# PERMIT

SEWAGE DISPOSAL SYSTEM

MARYLAND STATE DEPARTMENT OF HEALTH

SUBDIVISION Ellerslie Estates ROAD 3107 Ellerslie Court LOT 13

INDICATE NORTH - NAME ADJOINING ROADWAY AS BASE LINE  
 ELLERSLIE CT

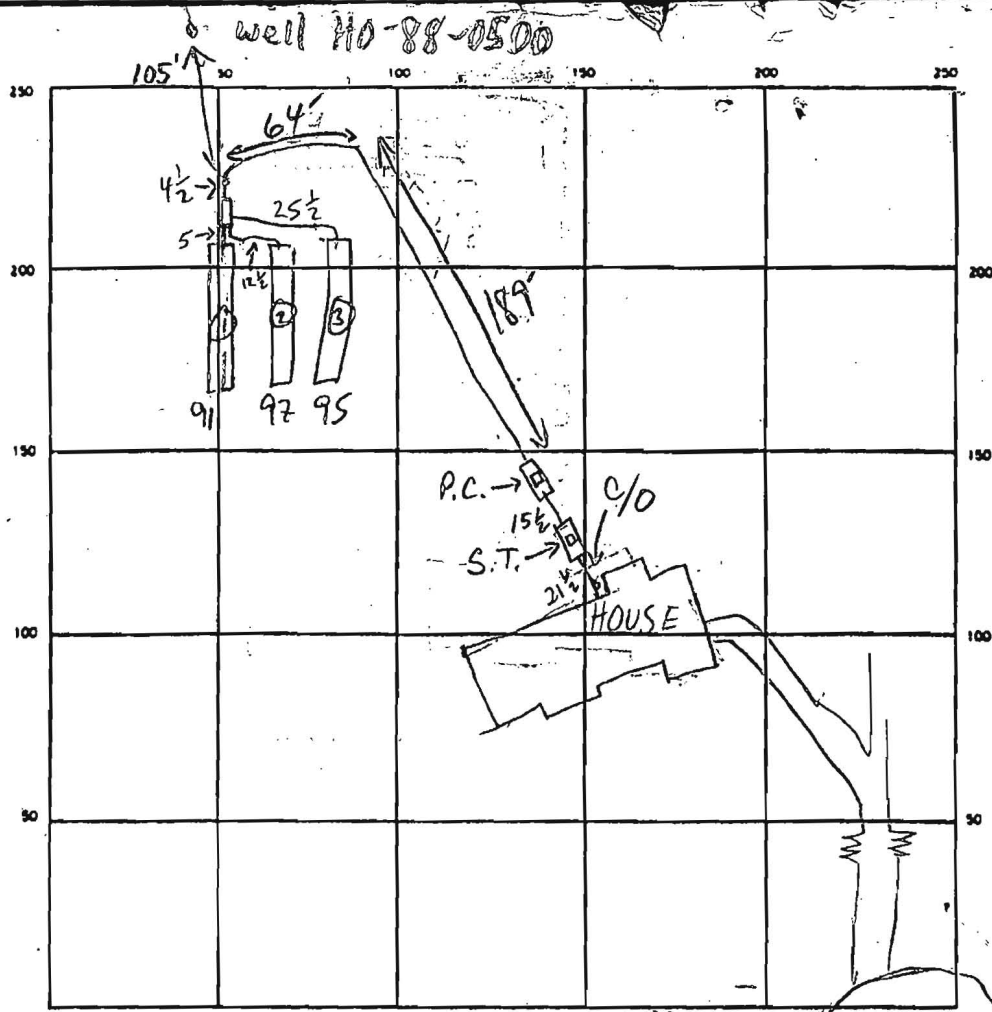
REMARKS 5/22/90 OK TO STONE TRENCHES, LOWER ALL EXC. TRENCH ENDS MR

5/23/90 OK TO COVER ALL TRENCHES WITH PUMPS REQUIRING C.W.

12/5/90 NO APPROVAL - PUMPS NOT OPERATING MR

12/7/90 PUMPS + SWITCHES ARE OK TOX (2) OF Mr. Kinross Men. + SUPERINTENDENT OF PULTE, present MR Vent of distribution box repaired - Final left sitting at PULTE
